DEPARTMENT OF HAWAIIAN HOME LANDS  
STATE OF HAWAII

**ADDENDUM NO. 2**

PAPAKOLEA SUBDIVISION SEWER IMPROVEMENTS  
AUWAIOLIMU SLOPE STABILIZATION AND SEWER LINES C & C-1 IMPROVEMENTS

**IFB-17-HHL-011**

ABBREVIATIONS

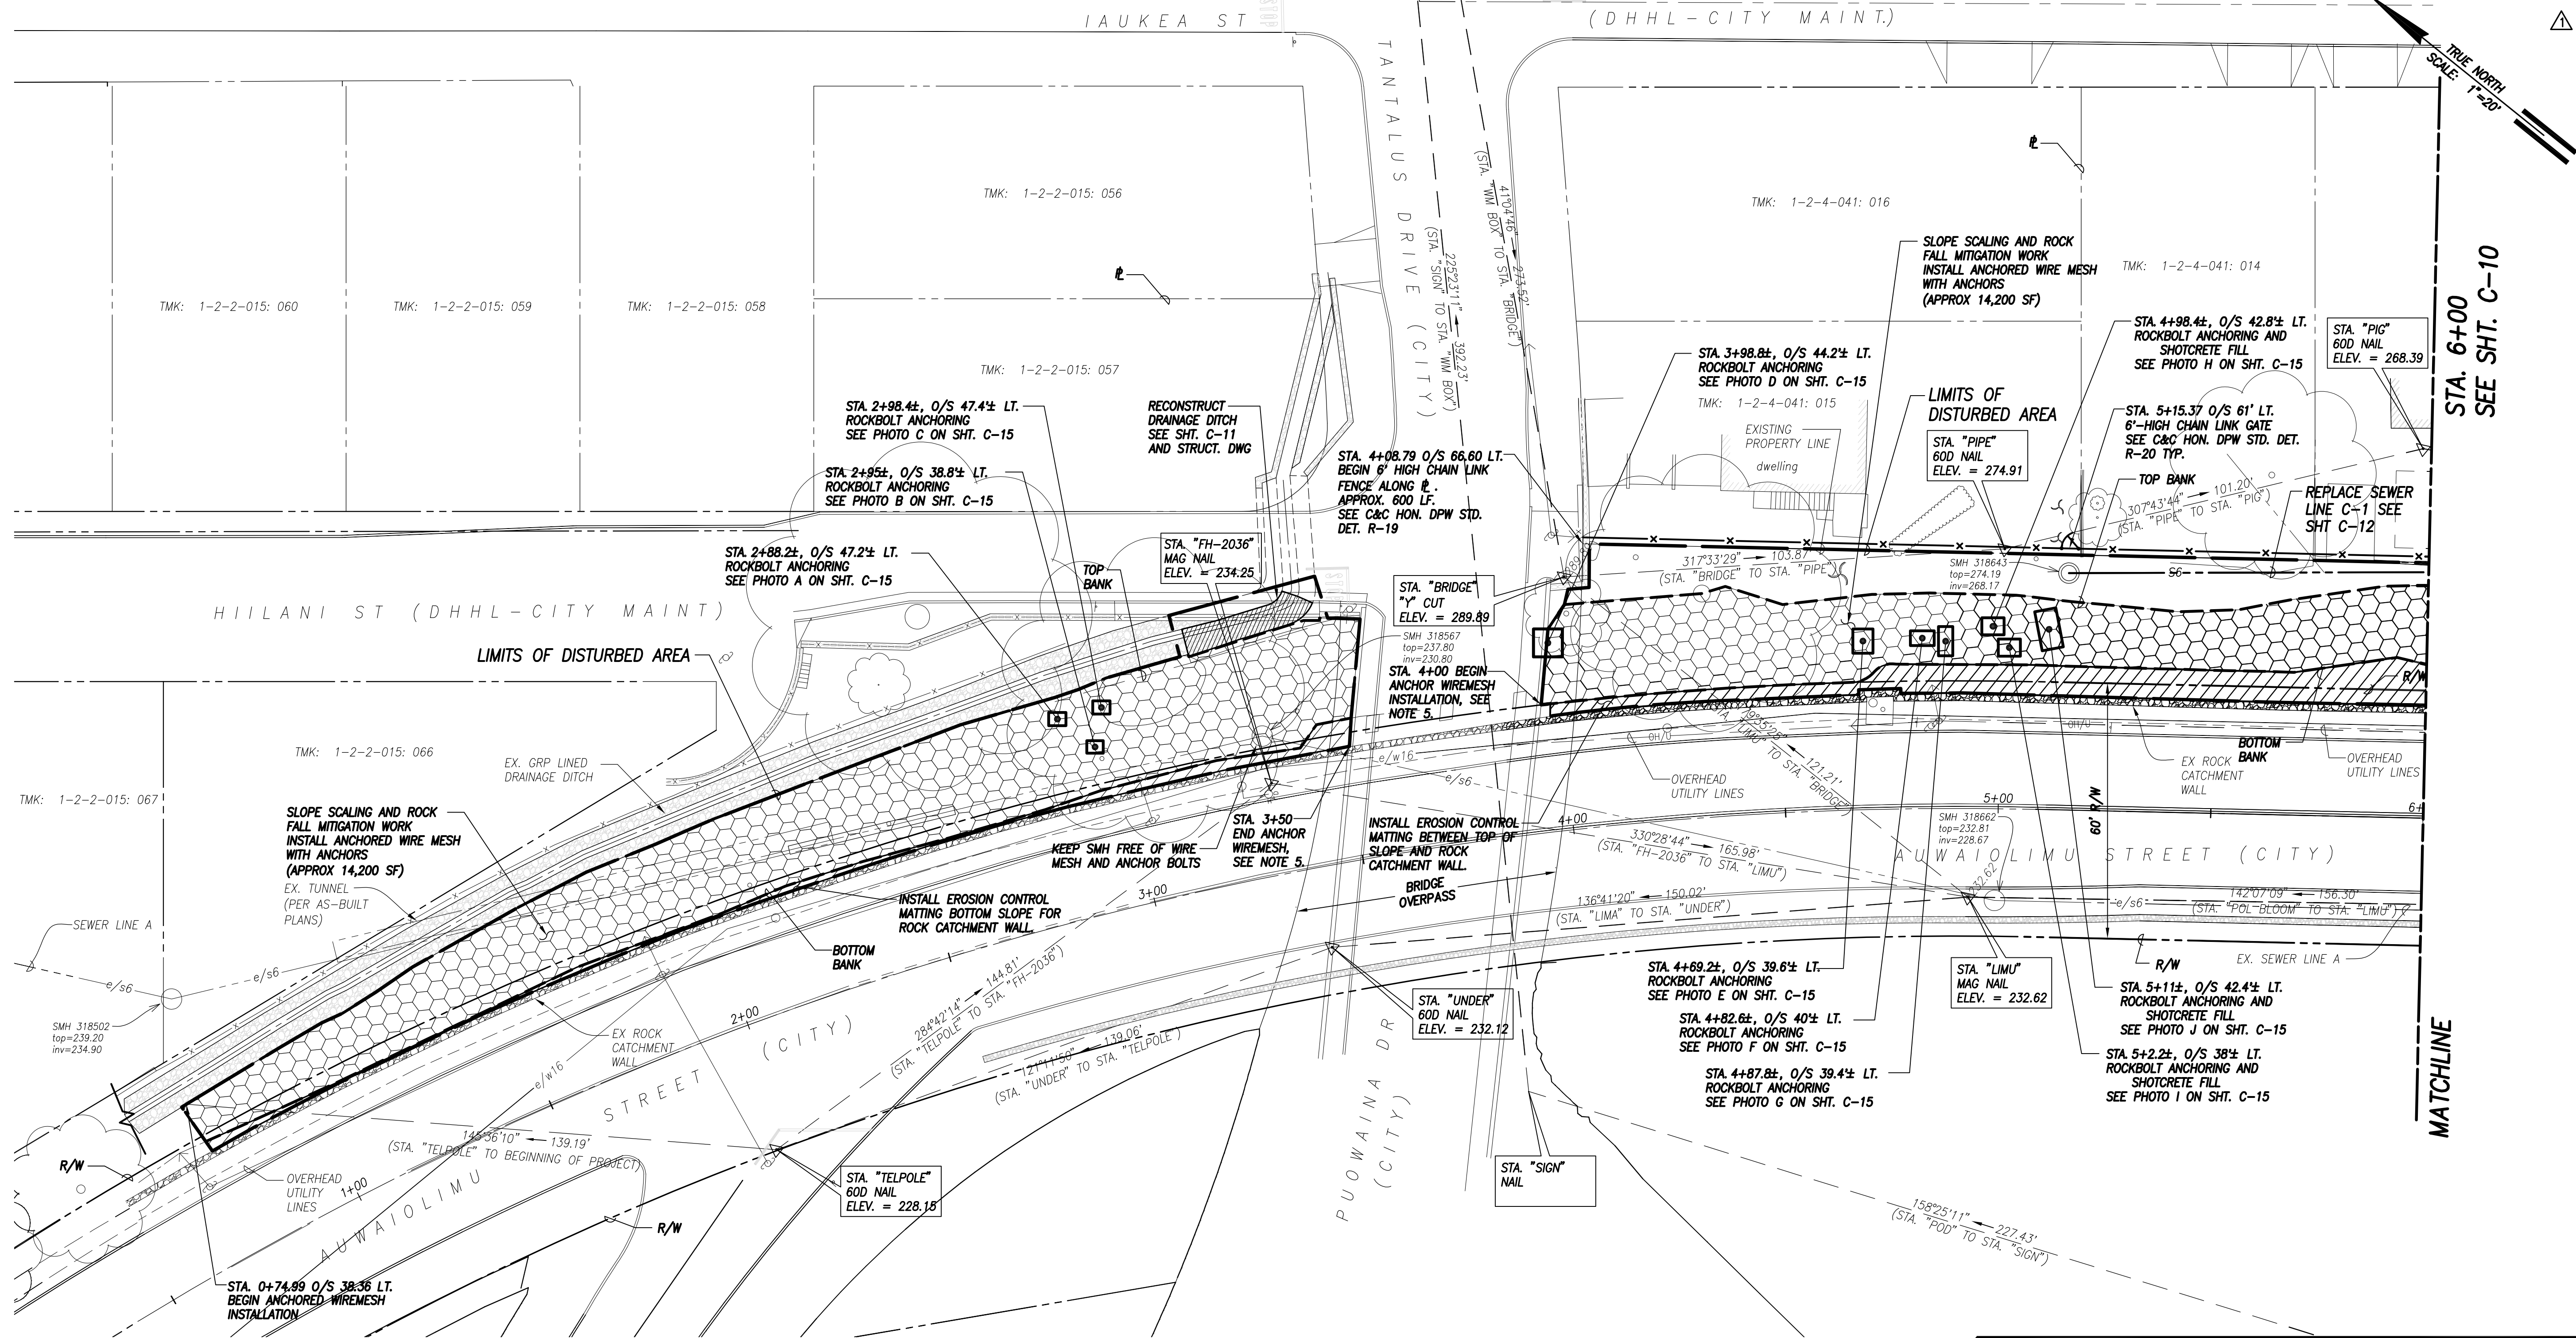
1. Sheet C-3 – “Construction Notes – 3 and Legend & Abbreviations”  
Revised HECO notes
2. Sheet C-9 – “Site Plan – 1”
  - a. Revised limits of work areas to meet existing slope stabilization under bridge
  - b. Revised bottom of slope stabilization limits west of overpass bridge
3. Sheet C-10 – “Site Plan – 2”  
Extend chain link fence at top of slope
4. Sheet C-14 – “Typical Sections”  
Removed erosion control matting under anchored wire mesh.
5. Sheet L-1 – “Planting Plan”
  - a. Revised plant schedule
  - b. Deleted seven (7) Alahee trees atop slope
  - c. Revised hydromulch/groundcover area
  - d. Extended chain link fence and kuhio vines to end of project area.

ENGINEER	AM/MH/JB					
DRAFTSMAN	SF/MH		3/27/17	ADD 2: REV HECO NOTES	AM	DHHL
CHECKED BY	AM/JN	REVISION	DATE	BRIEF	BY	APPROVED
		R. M. TOWILL CORPORATION 808 842 1133 2024 North King Street Suite 200 Honolulu Hawaii 96819-3494 Department of Hawaiian Home Lands PAPAKOLEA SEWER IMPROVEMENTS AUAUOLIMU SLOPE STABILIZATION & SEWER LINES C & C-1 IMPROVEMENTS Papakolea, Honolulu, Oahu, Hawaii				
CONSTRUCTION NOTES - 3 AND LEGEND & ABBREVIATIONS						
THIS WORK WAS PREPARED BY ME OR UNDER MY SUPERVISION AND CONSTRUCTION OF THIS PROJECT WILL BE UNDER MY OBSERVATION. "OBSERVATION OF CONSTRUCTION" IS DEFINED IN CHAPTER 16-115, HAWAII ADMINISTRATIVE RULES ENTITLED "PROFESSIONAL ENGINEERS, ARCHITECTS, SURVEYORS AND LANDSCAPE ARCHITECTS"						
		Apr 2018 LIC. EXP.

SITE PLAN - 1  
SCALE: 1" = 20'

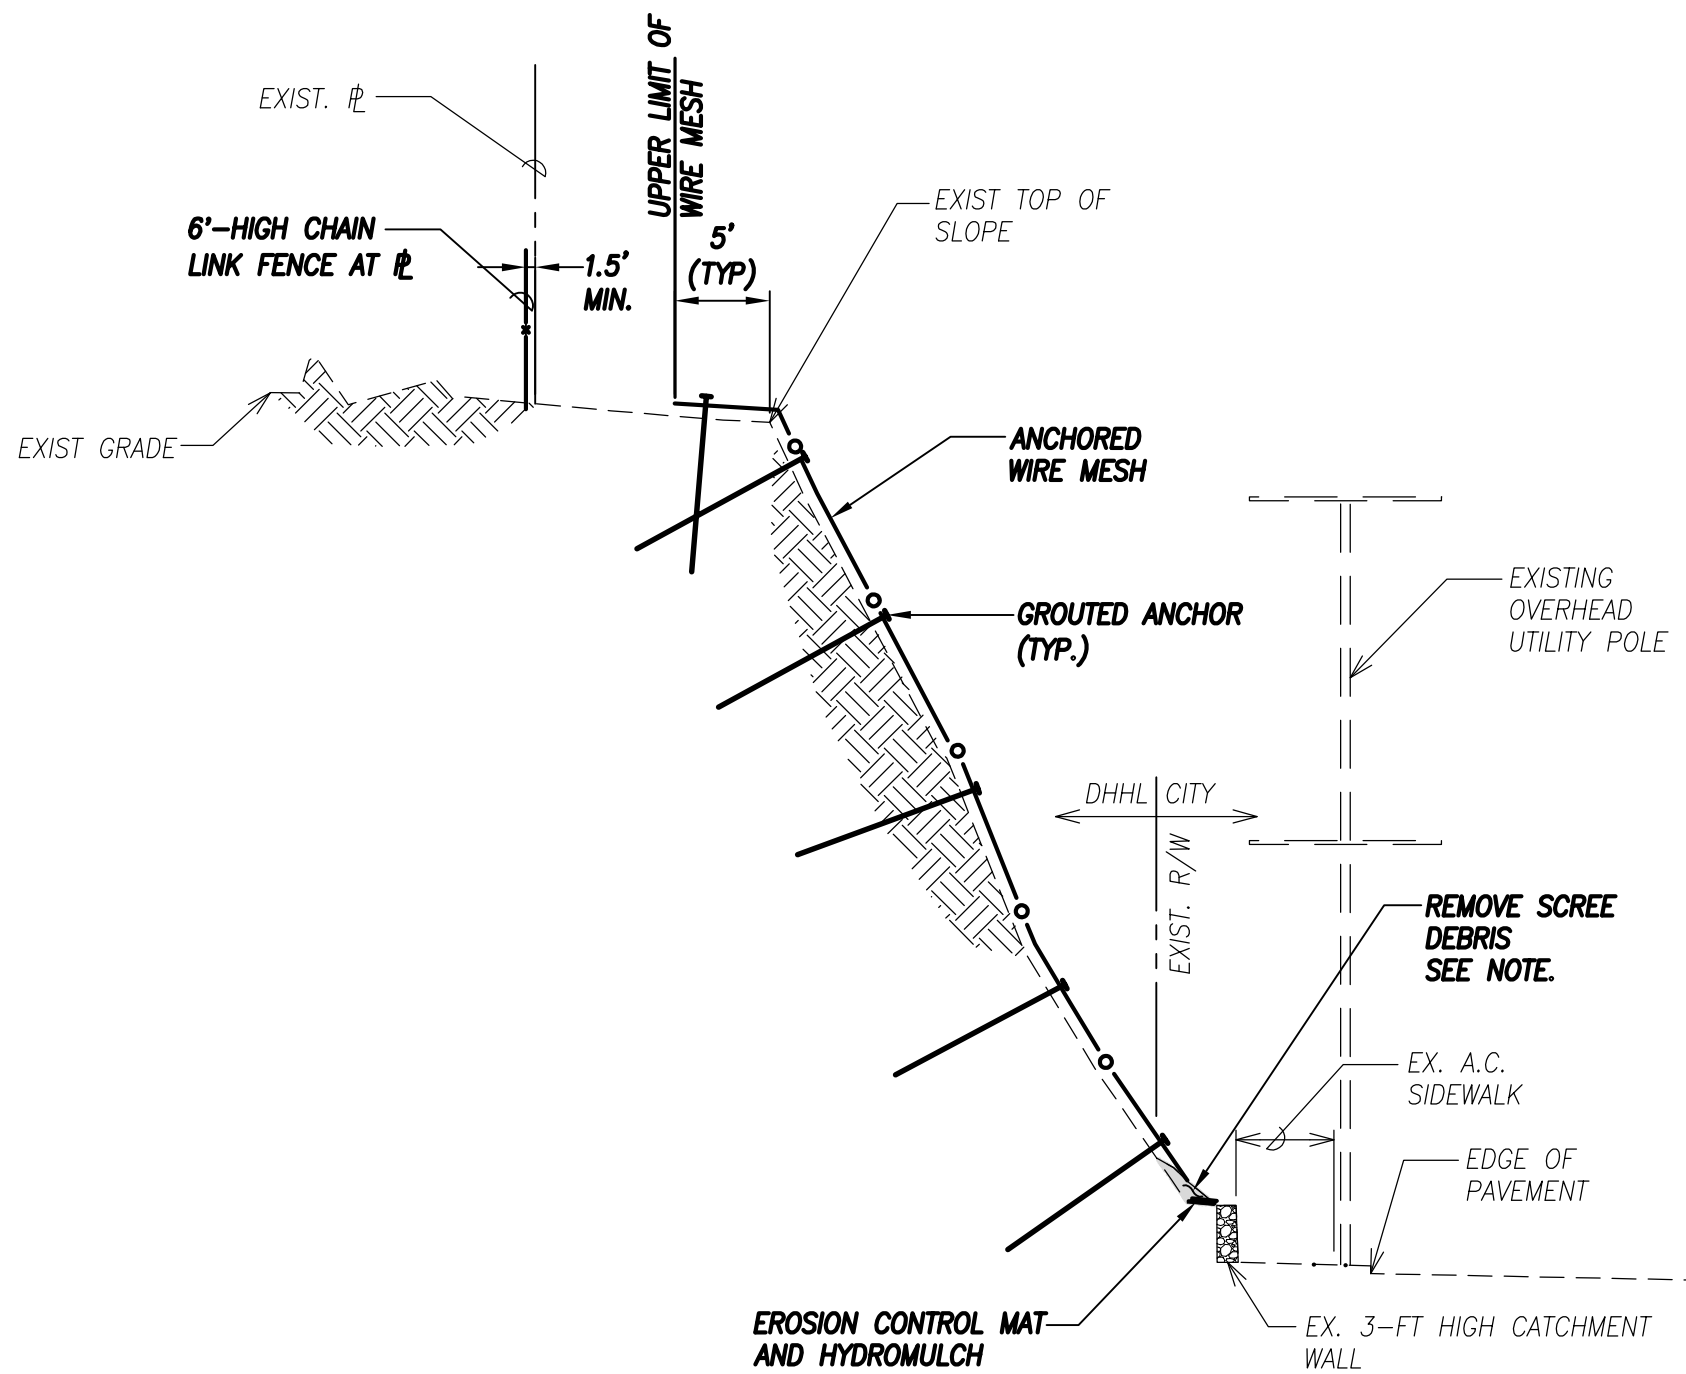
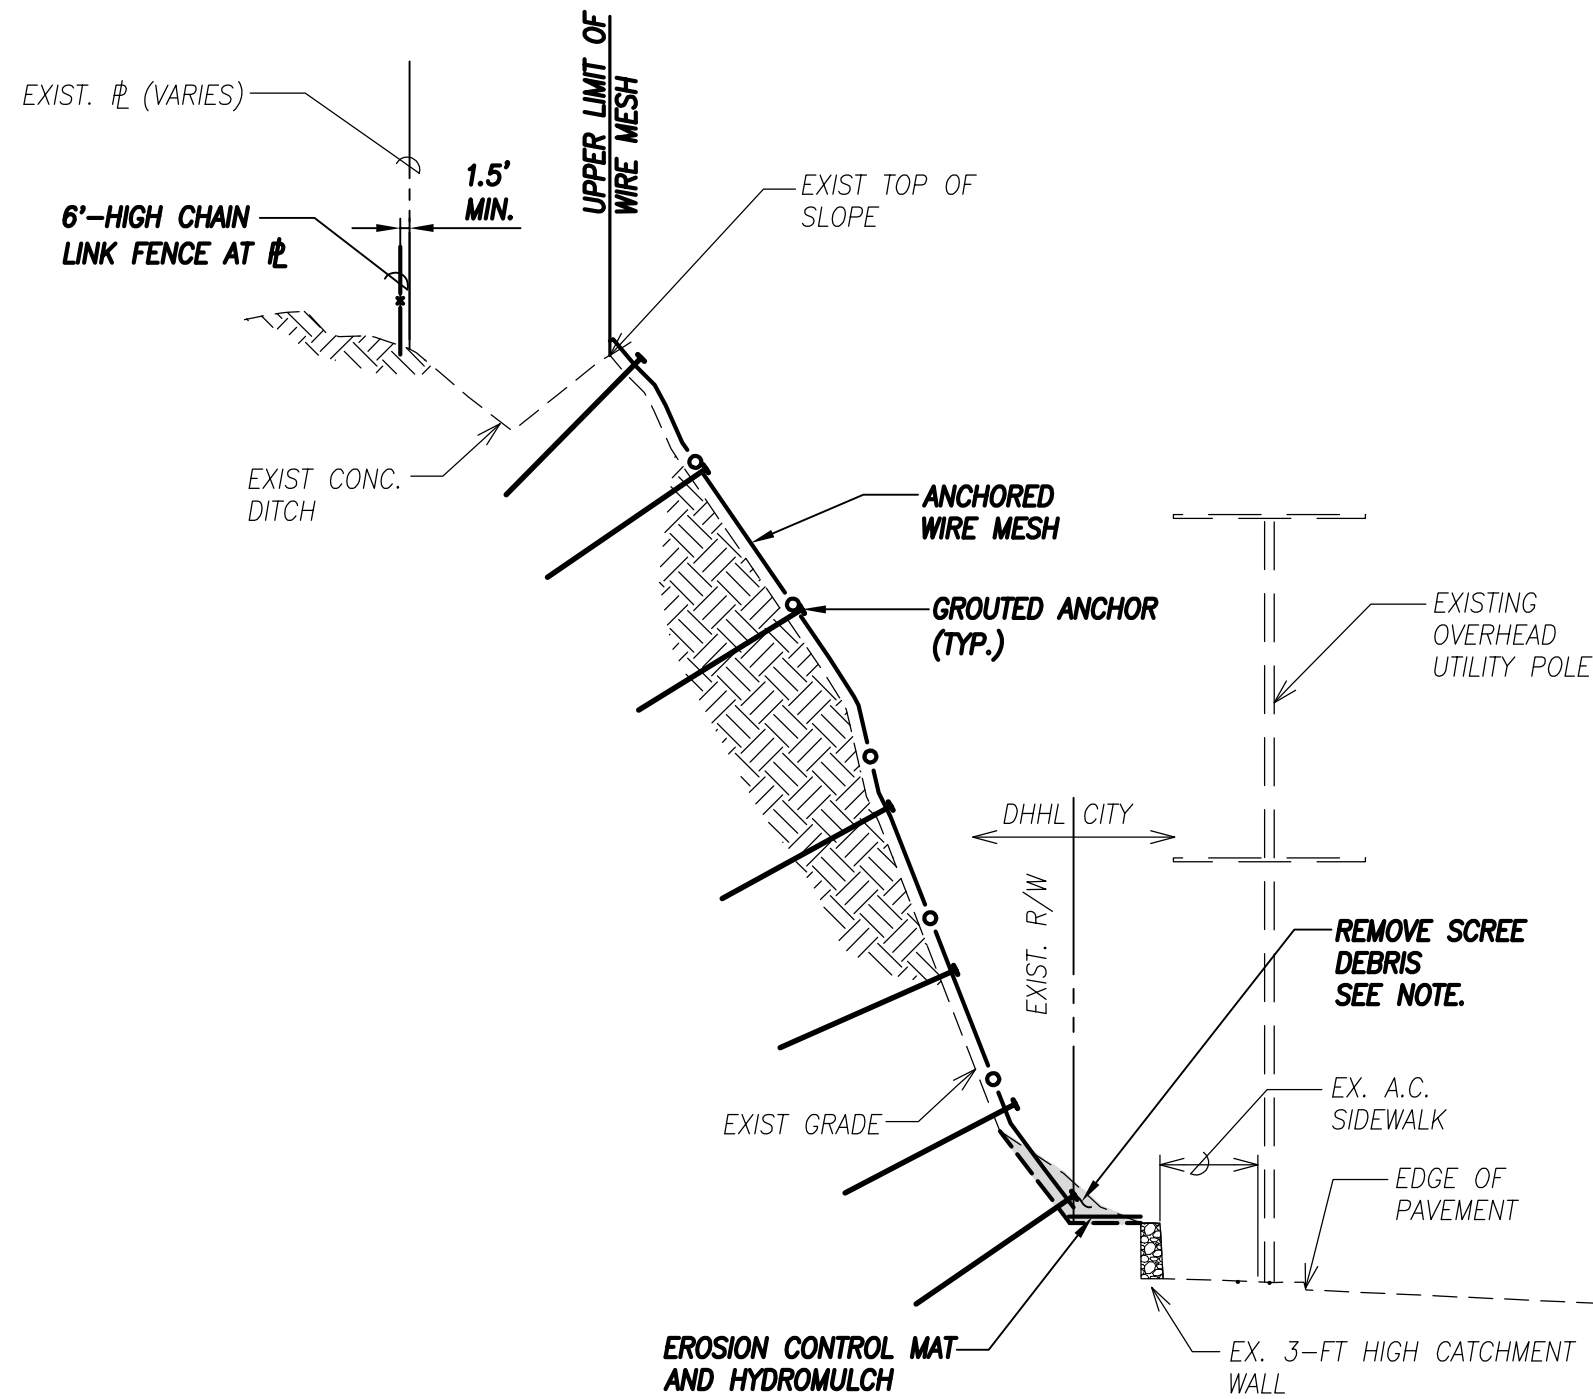
ENGINEER	JB/MH	REVISION	3/27/17	ADD 2: LIMIT OF WORK	AM	DHHL
DRAFTSMAN	SF/MH/MY	DATE		BRIEF	BY	APPROVED
CHECKED BY	AM/JN					
R. M. TOWILL CORPORATION Department of Hawaiian Home Lands PAPAKOLEA SEWER IMPROVEMENTS AUWAILIMU SLOPE STABILIZATION & SEWER LINES C & C-1 IMPROVEMENTS Papakolea, Honolulu, Oahu, Hawaii						
SITE PLAN - 1						
FILE POCKET FOLDER NO.
